**HUDSON HIGHLAND FJORD TRAIL
SHORELINE SEGMENT
SEA LEVEL RISE WORK SESSION**

**DESIGN MEETING MINUTES
MARCH 30, 2017**

Re: Hudson Highlands Fjord Trail
Shoreline Segment
D&B No. 3750

ELEVATED TRAIL - CONCEPT C (CANTILEVERED CONCRETE PILINGS)

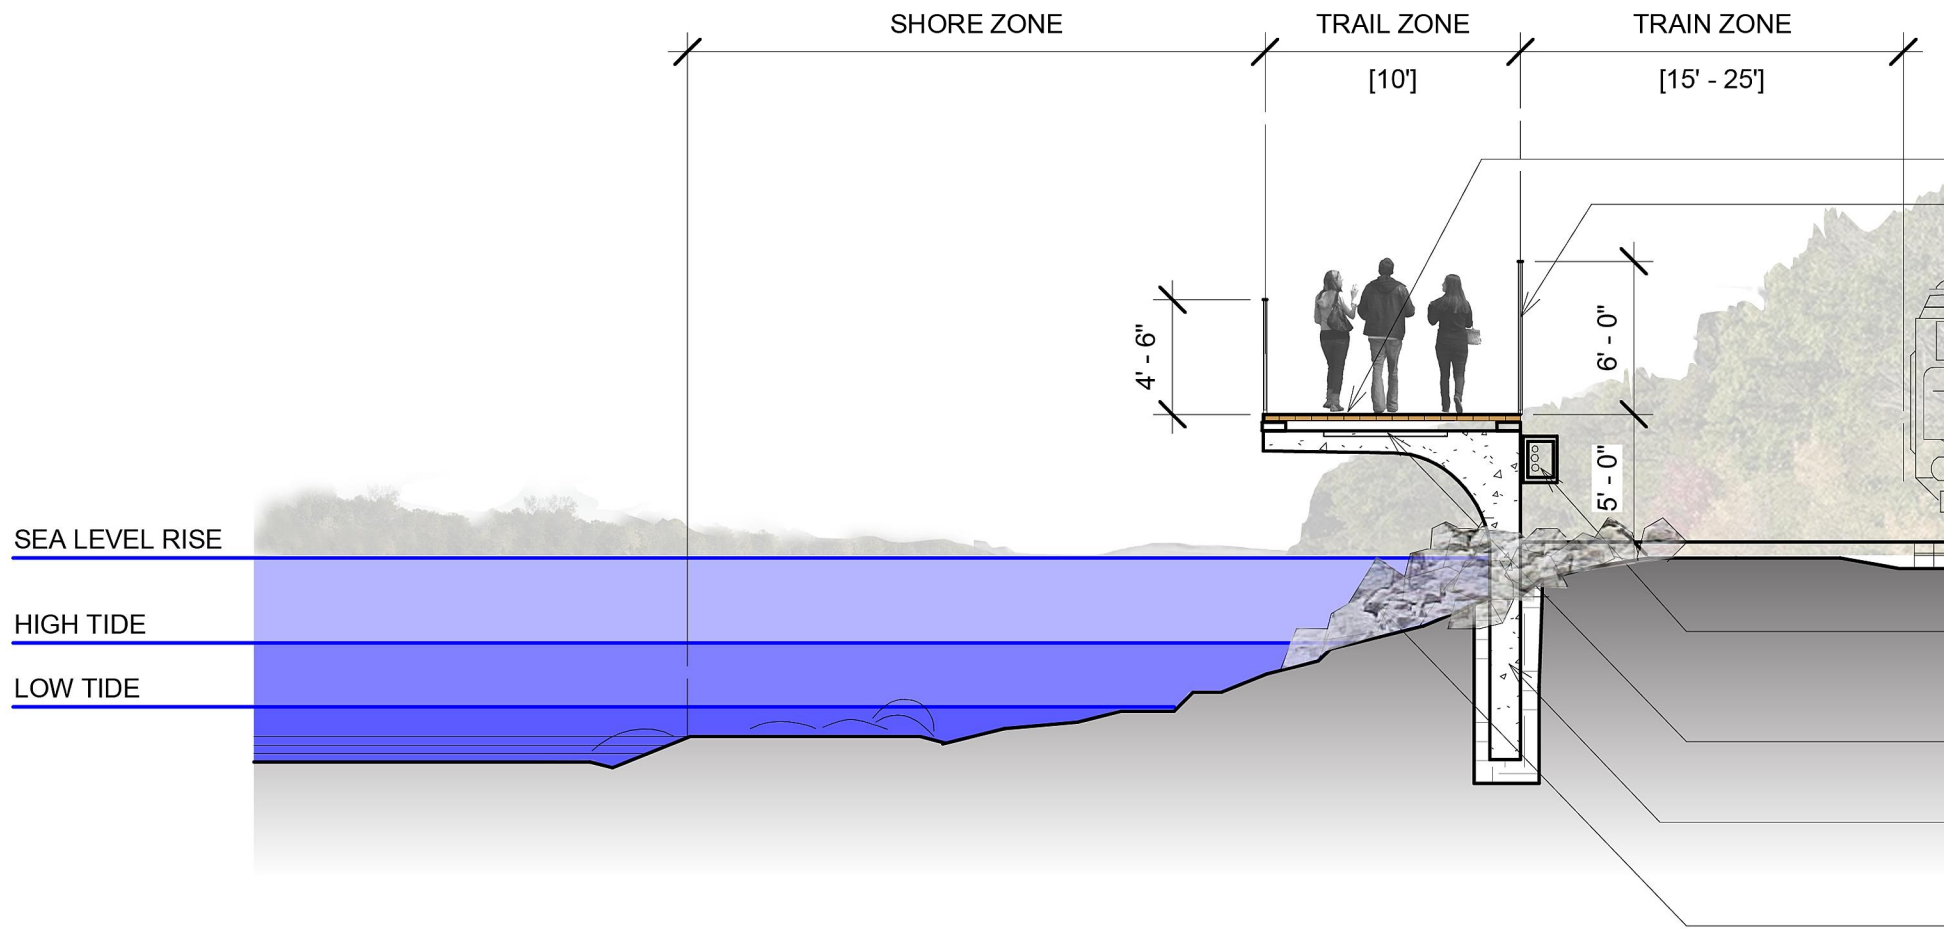
7. With regards to a trail along this shoreline section, MTA is concerned with maintaining access along the tracks, at least 12 feet is needed for vehicle to access the tracks. In addition, safety is a concern, a positive barrier (fence) would be required to segregate the at-grade trail from the tracks. The design concepts put forth seem to accommodate both requirements. Visual impacts to riders will also be a factor in their review.

11. With regard to design, NYSDEC indicated that, where shoreline stabilization is required, neither geotextiles nor gabion baskets should be used. Existing vegetation should be maintained wherever possible. For rip rap application (really the only shoreline stabilization option in this reach of the Hudson River), joint plantings both above (mainly) and below MHW should be considered.

13. Bathymetric data is reportedly available for the area and the dynamics of the shore are critical in selecting a shoreline stabilization method.
14. After reviewing a variety of trail designs, the group concluded a cantilevered trail section on land-based piers may be best suited. D&B suggested such a cantilevered section can be fitted with a pre-cast concrete box along the length of trail to house MTA signaling cable. This would allow the cable to be installed above the sea level, easily accessible above grade and reduce costs for excavation, etc. The base of this structure could also serve as a protective element for sea level rise and storm surge and could be designed in a way that height is added as sea levels rise. Consider an adaptive design that will allow for components to be changed out and or added; one that lives and changes with SLR. Approximately 1,000 feet of this cantilevered trail is contemplated. The DEC noted that some rip rap will be acceptable for stabilization of the structure initially. But the rip rap should not be extended to the height of the Sea Level Rise projection. In the future, if the rip rap is needed it will likely meet issuing standards. But for the initial trail design and implementation the amount of fill on the shore should be limited to what is necessary initially.

1. D&B to create rendering of concept plan that was contemplated in the meeting and may meet the needs of all parties. (Completed and attached herein.)
2. Detailed Engineering Feasibility Plan is underway.
